Failed Inspections for 2024

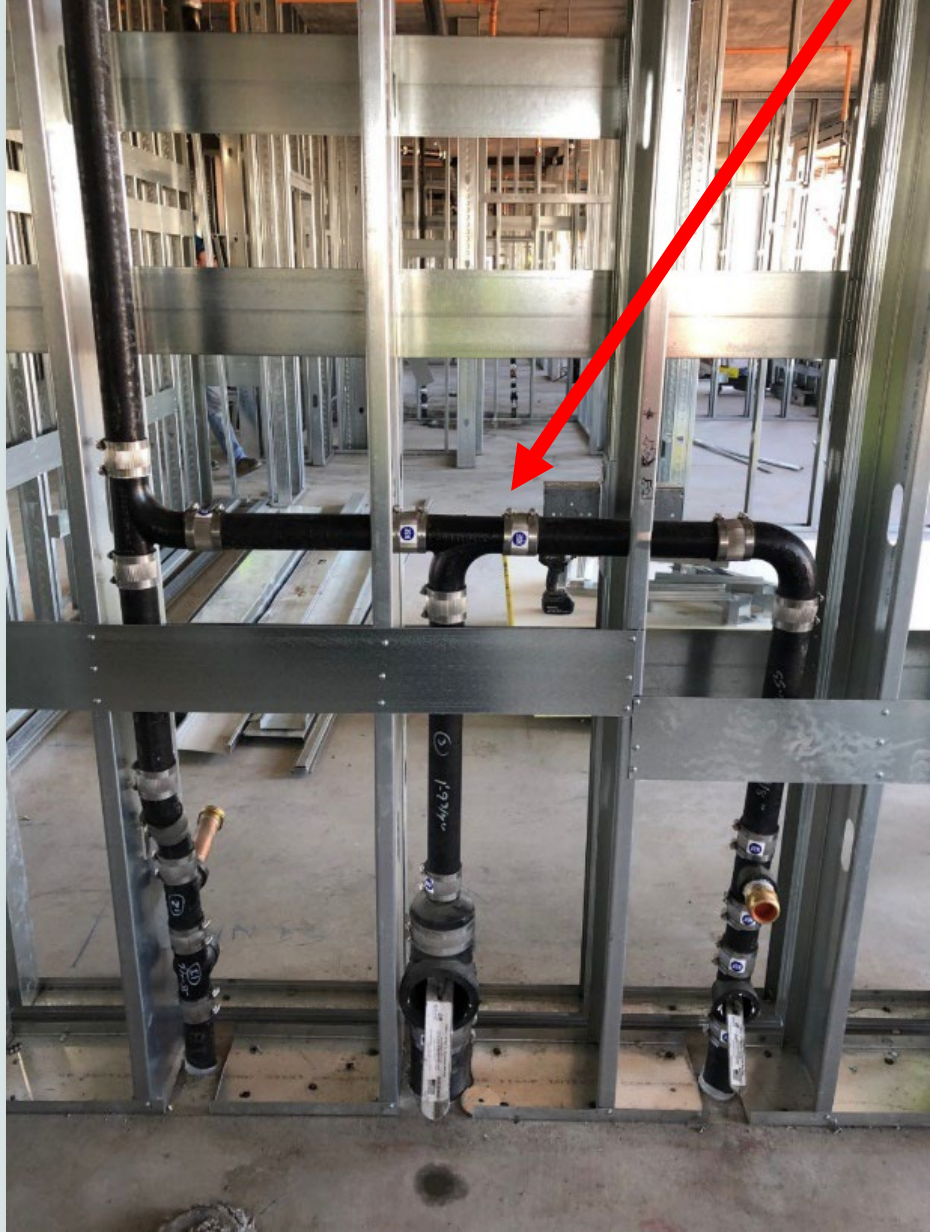
CPC 905.2: A fixture vent must take off from the waste line before a new fixture enters the waste line. Also:

- The wall plates are over-notched.
- The structural floor joist has been removed.
- The studs are damaged.
- The vent cannot be reduced in size.
- The shower waste line is incorrect.
- The hot water lines are not insulated.
- The toilet waste line slopes back towards the toilet.

8 code violations within 9 square feet!

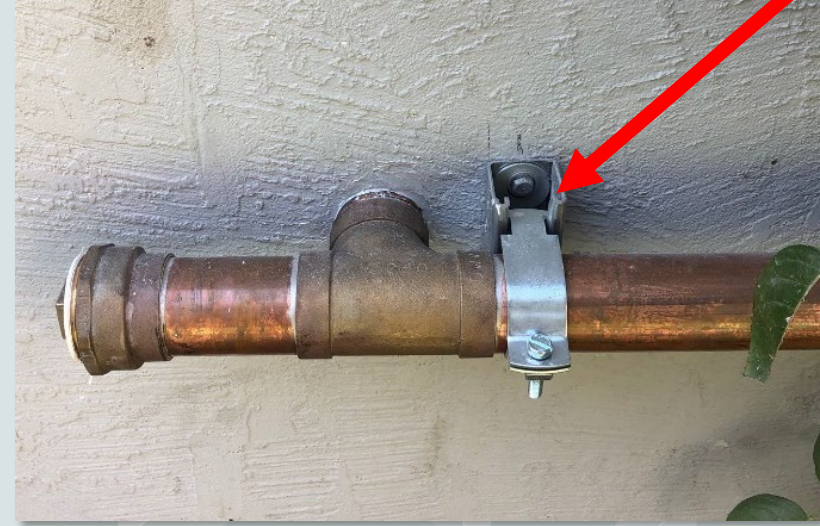
CPC 605.15 & 310.6: Dissimilar metals.

After time it will look like this and start leaking.

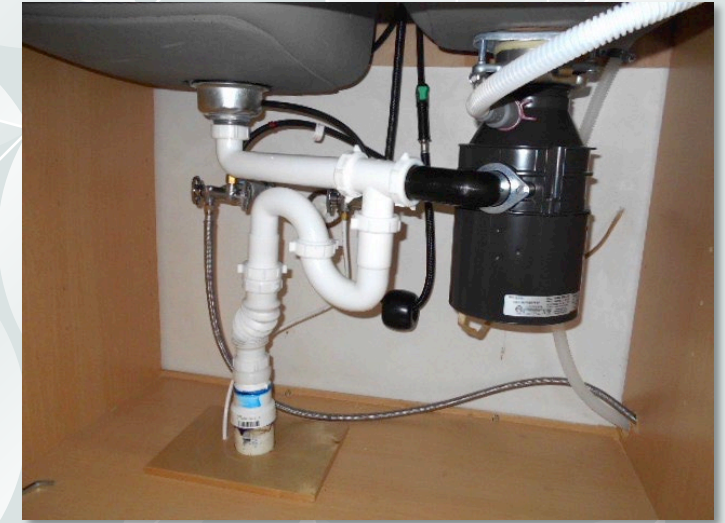
CPC 1003.1.1: Corrugated pipe is not allowed.
“Shall have a smooth and uniform interior”

CPC 1004.1: “S” traps, bell traps, and crown-vented traps shall be prohibited.

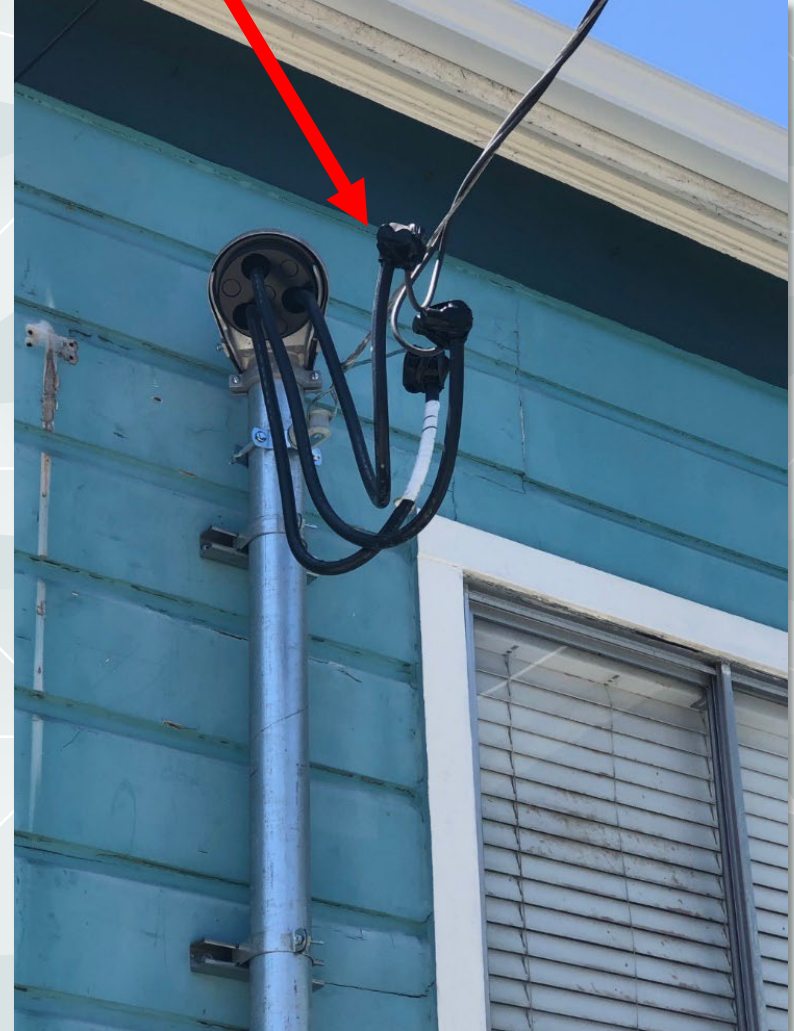
CEC 230.9.A: Service entrance conductors must be 3" from operable windows.

This is very dangerous!!!

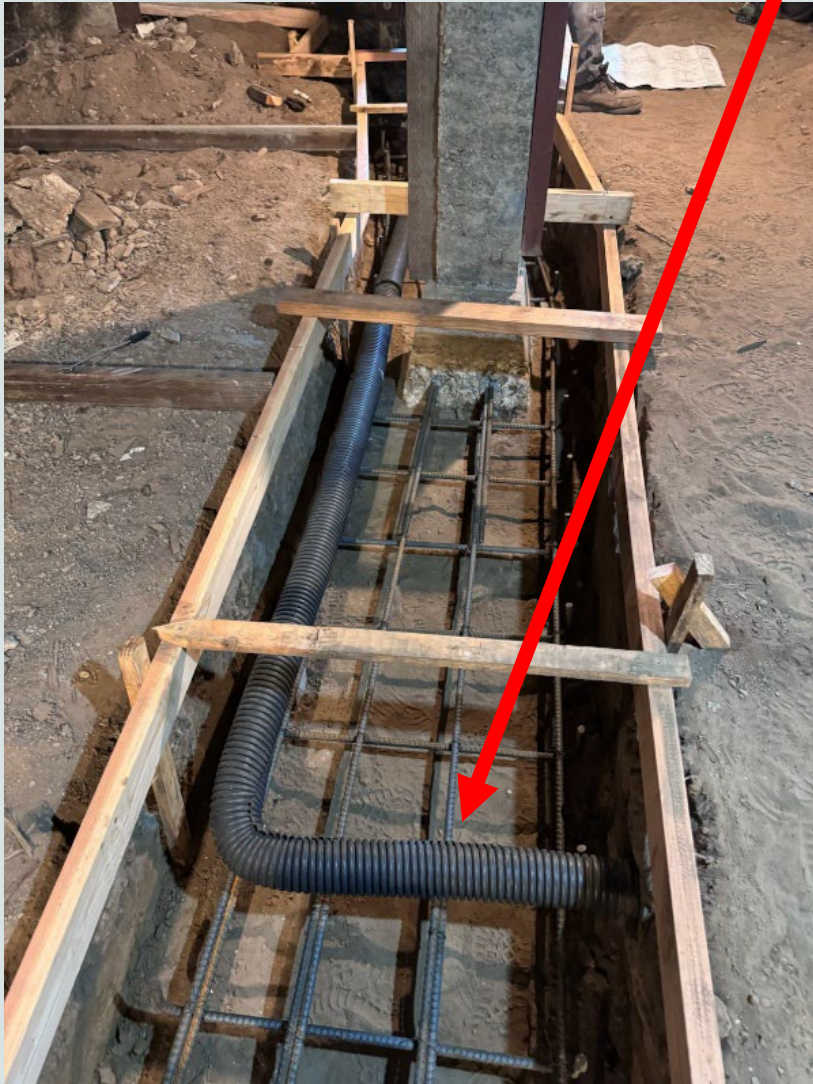
CPC 312: A gas line cannot be installed in the foundation footing.

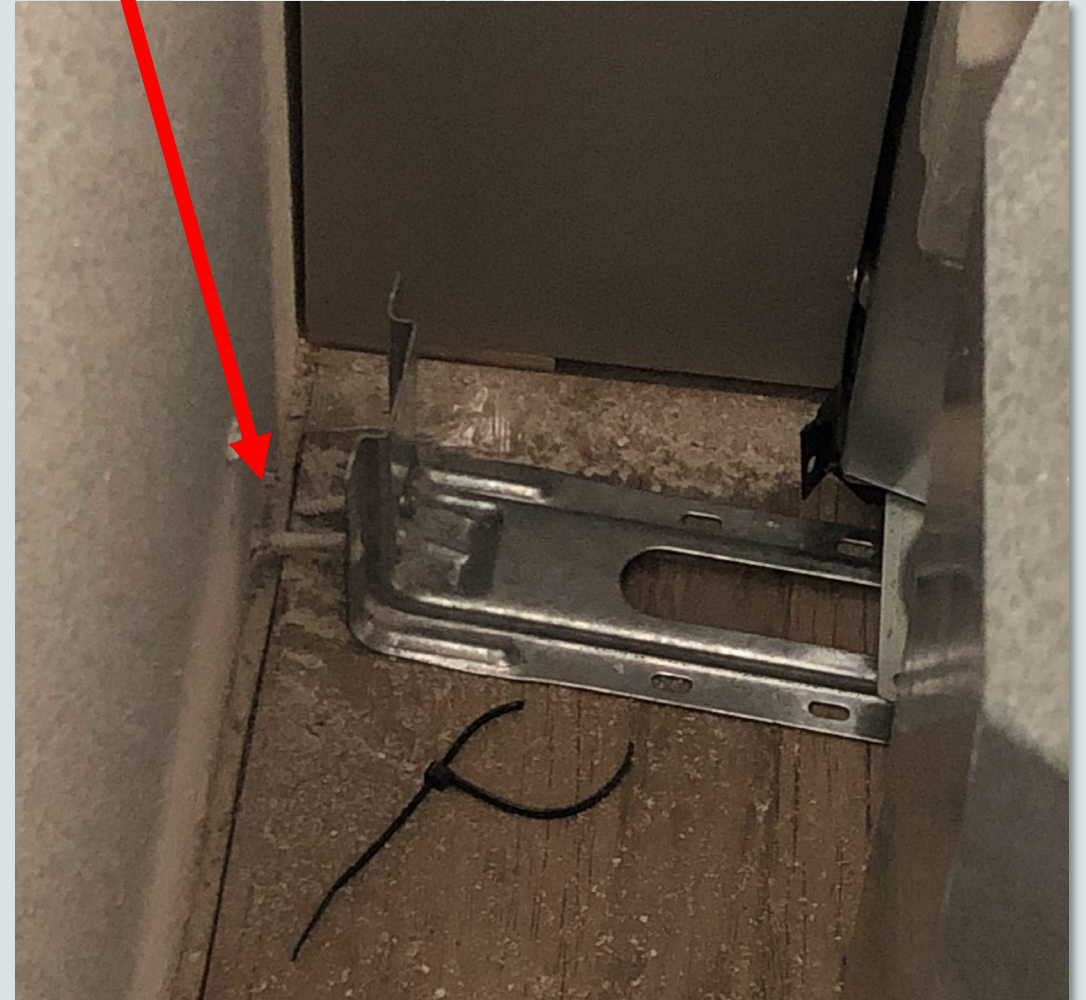
CRC R602.6: Corner post over notched for electrical.

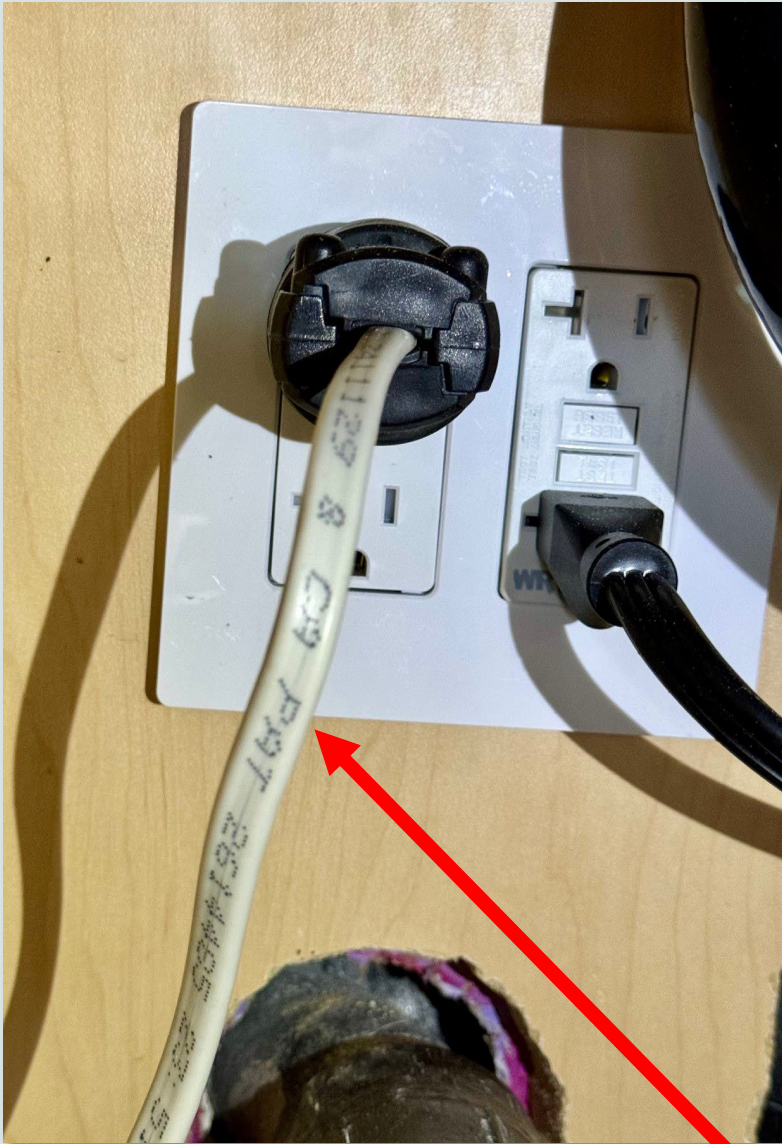
CPC 905.3: Cannot have a San-Tee on its side.
Vent take-off must be 6" above the flood rim.
CRC R602.6 Over-bored studs.

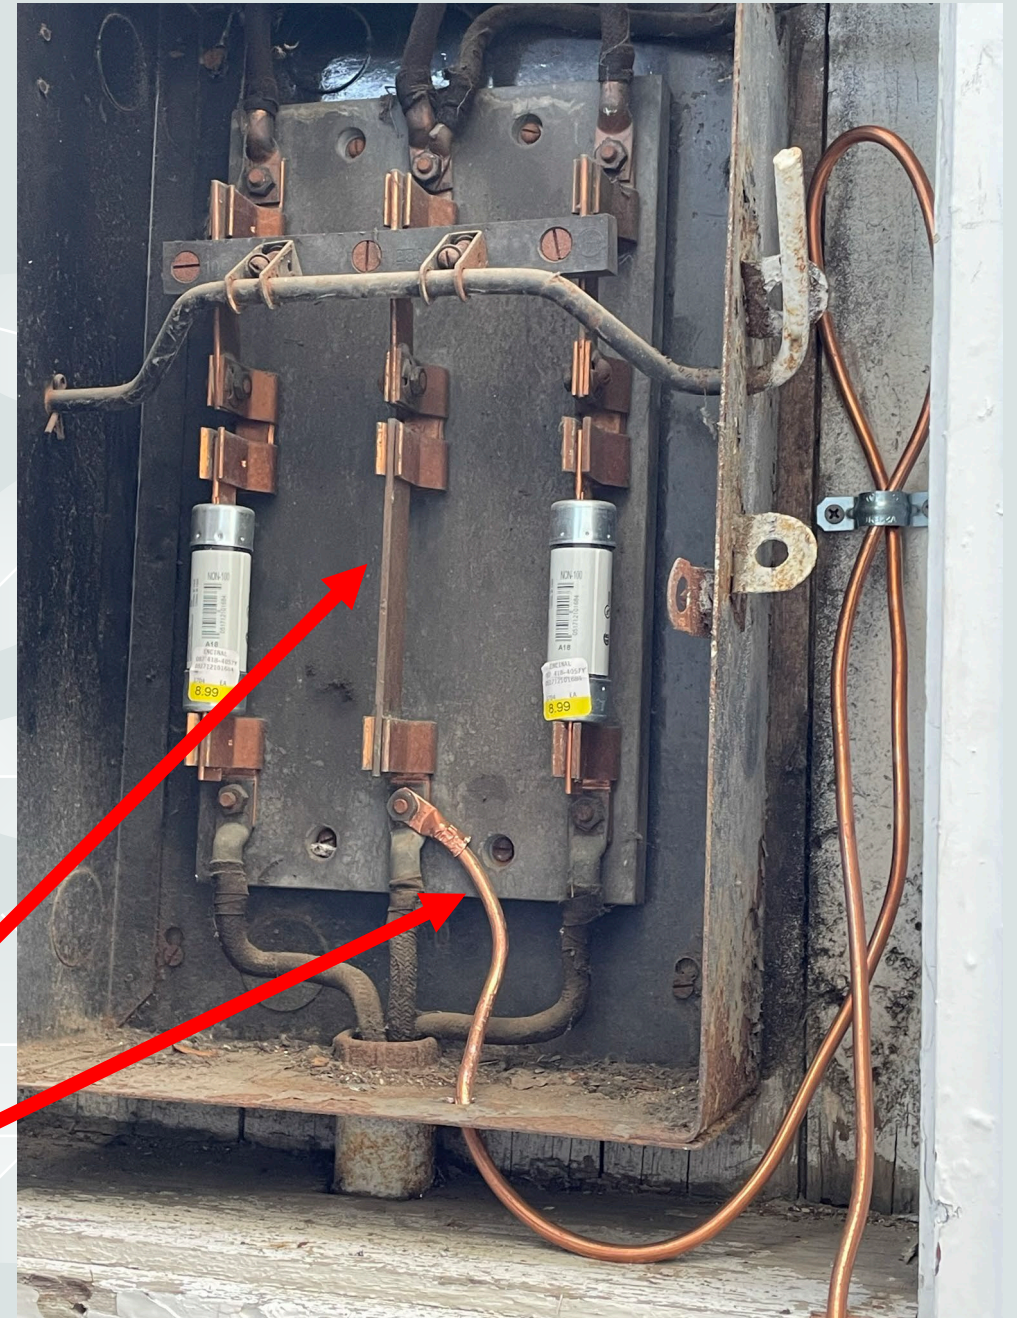
That is not a fuse

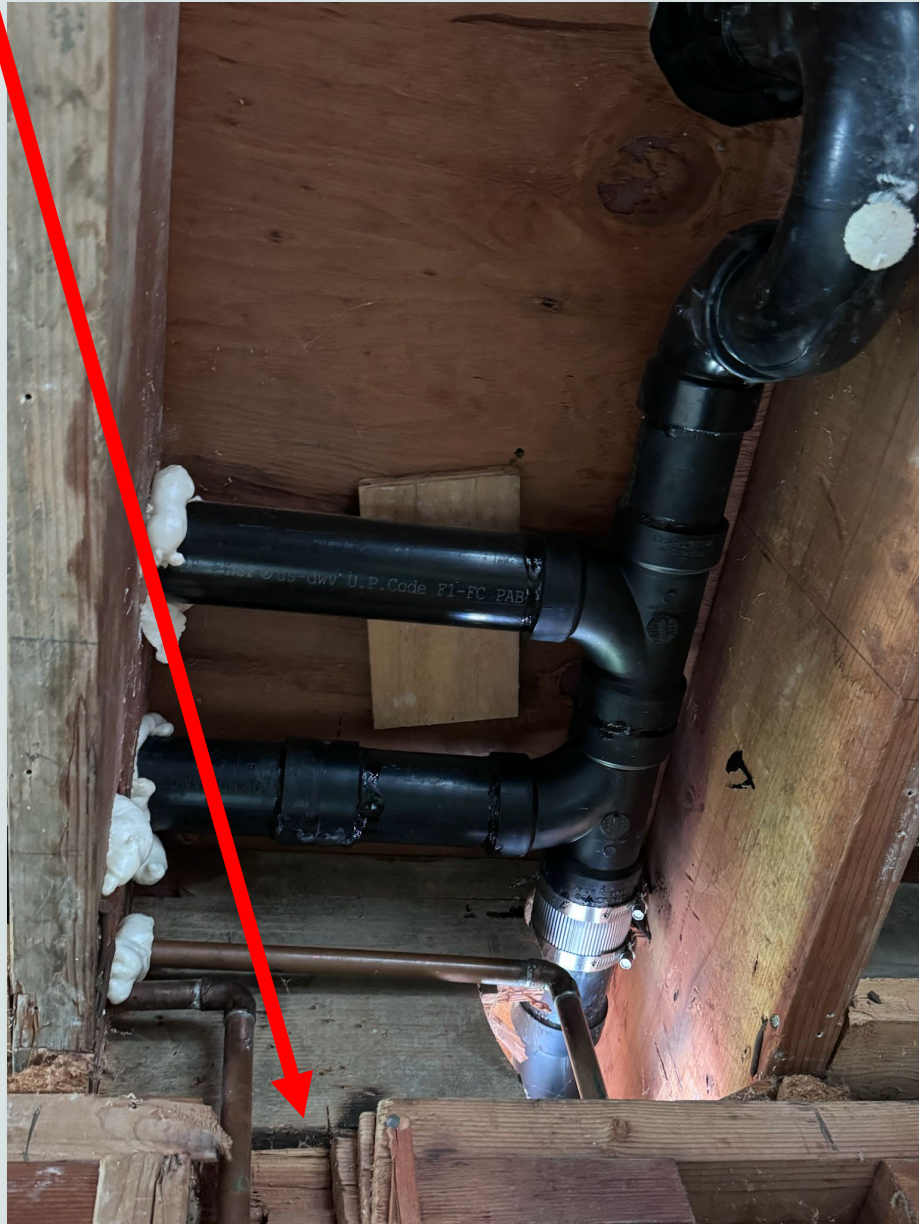
CPC So many plumbing violations – not sure where to start.
